Medical Products Division/3M

Joseph DelMedico  
U. S. Nuclear Regulatory Commission  
License Management Branch  
Division of Fuel Cycle and Material Safety  
Washington, D.C. 20555

Re: Control No. 99111

This letter is to provide additional information in support of our license amendment application regarding the distribution of I-125 Seeds. Included in this information, as Part A, are responses to questions and concerns noted in your letter of May 11, 1979. Responses to requests made by Mr. Earl Wright, following the sealed source review, are presented as Part B.

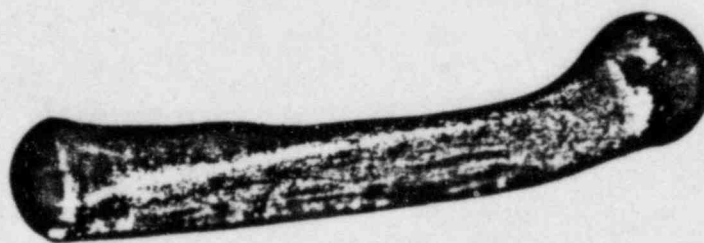
Results of impact and percussion tests of prototype sources conducted per ANSI N44.1-197 (see ANSI N44.1 paragraphs 4.2.2 and 4.2.3).

Visual inspection indicated that the seed configuration was altered significantly by the test (see attached photograph). The central portion of the seed, between the end welds, was crushed flat except for a slight elevation at the location of the gold ball contained within. The end welds did not appear to lose their integrity (i.e. separate from the titanium can). The crushed seed left an impression in the lead plate.

Data tabulated below indicate that the I-125 Seeds maintain their integrity under the conditions of the percussion test.
